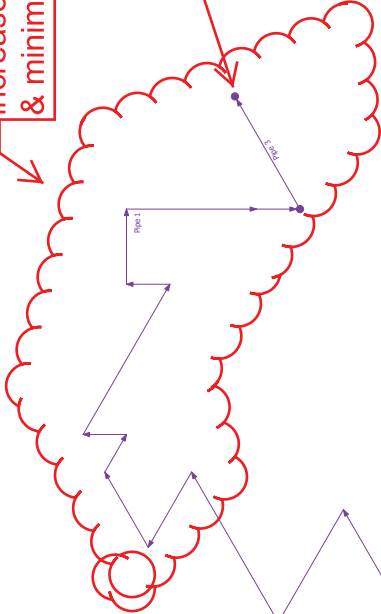
increase this to 6"
& minimize elbows
